**SITE PLAN** 236 UNITS  
1" = 40'

**Site Plan**  
 A 236-Unit Apartment Project

**Bradley Heights Apartments**  
 Puyallup, Wa

**A2**

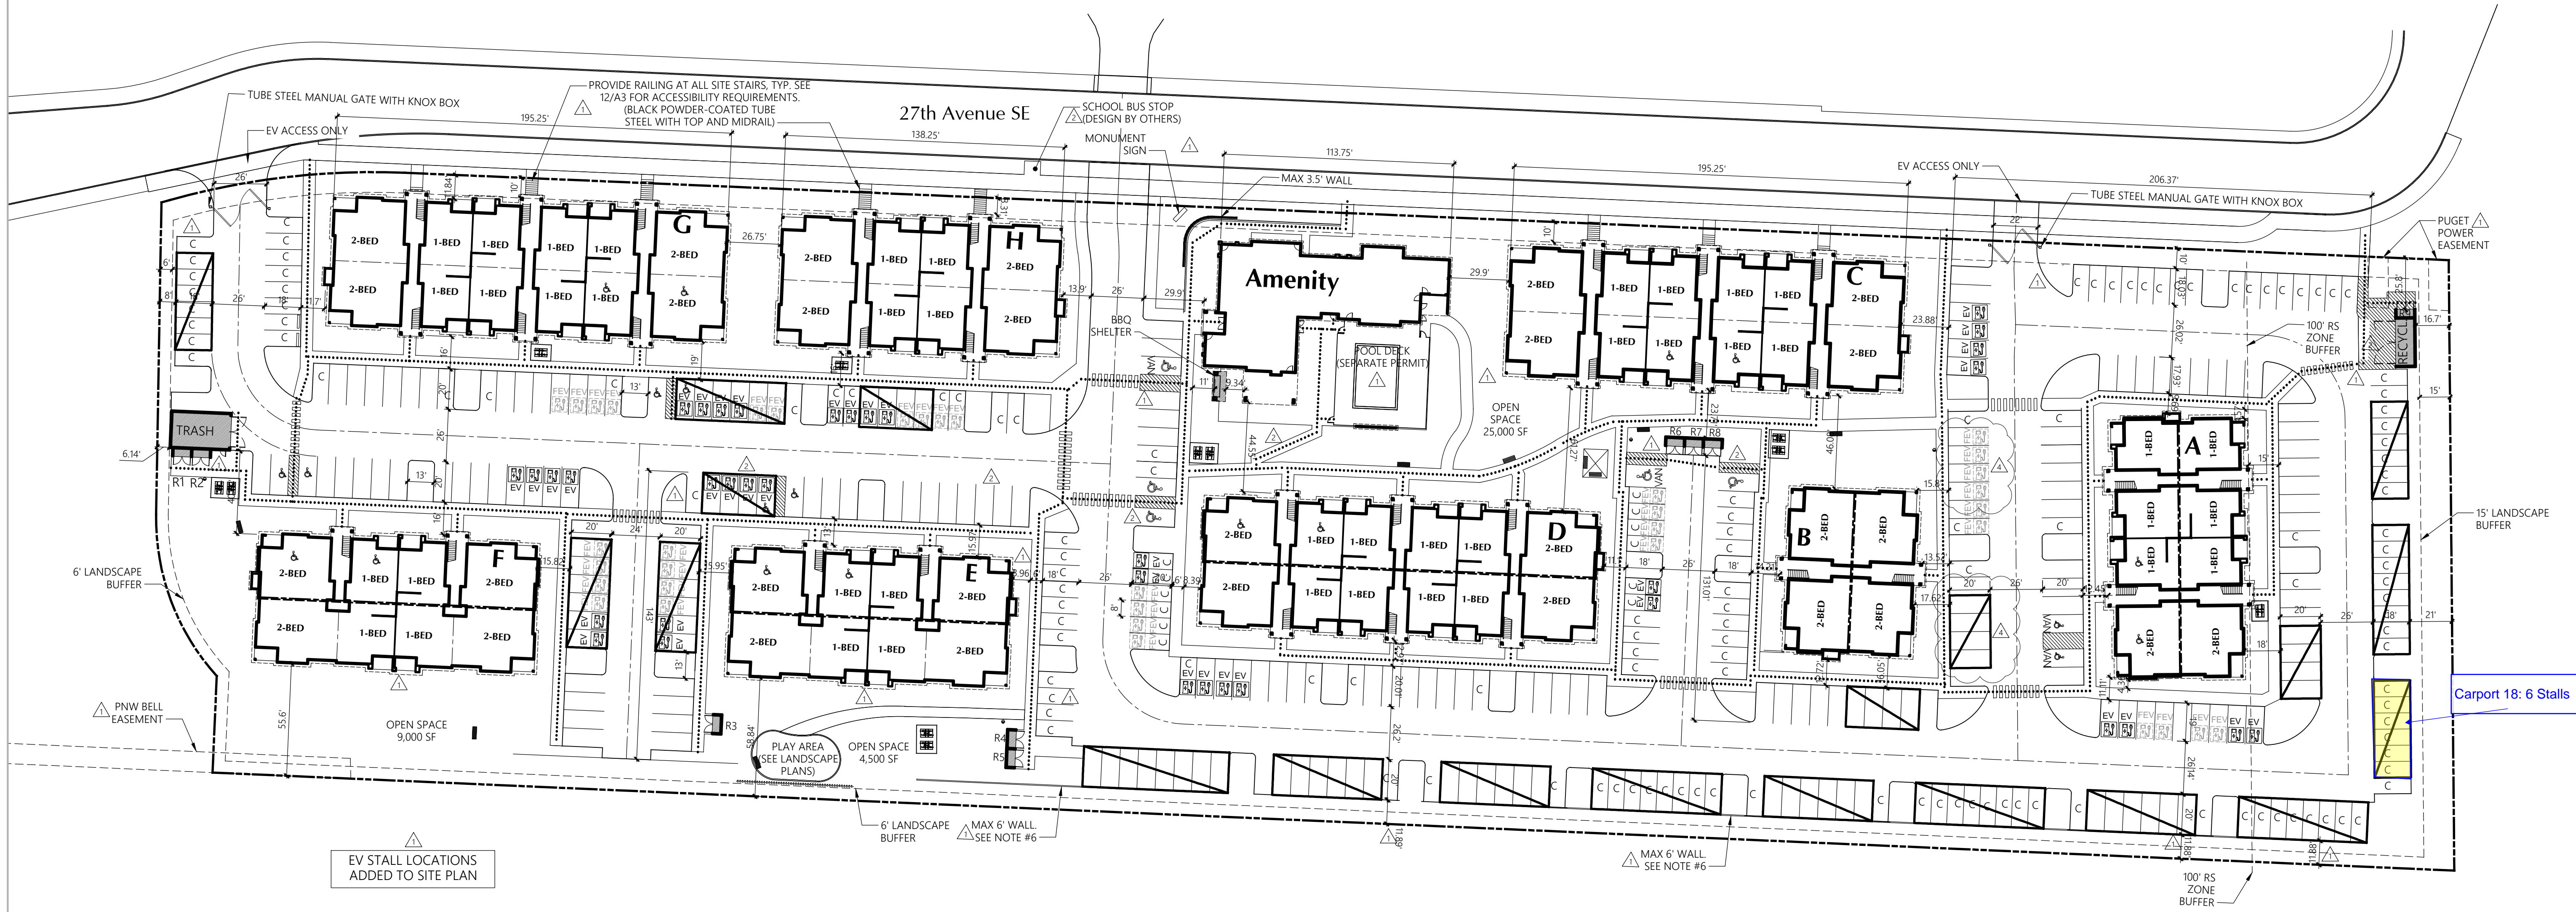
No proposed footings, posts, or supports shall be constructed on or above any existing public utility connections without first relocating the utility services or protecting it in place.

Roof downspout control is required. Steps shall be taken to prevent drainage onto adjacent lots. Refer to City standard details 02.05.01 & 02.05.05 for typical control methods. Stormwater runoff shall not concentrate to neighbors.

PARKING COUNTS CORRECTED

Staff: JH/uel/ew  
 Date: 04/02/2026  
 Front, rear, and side yard property lines shall be marked with string from surveying pins prior to footing inspection.
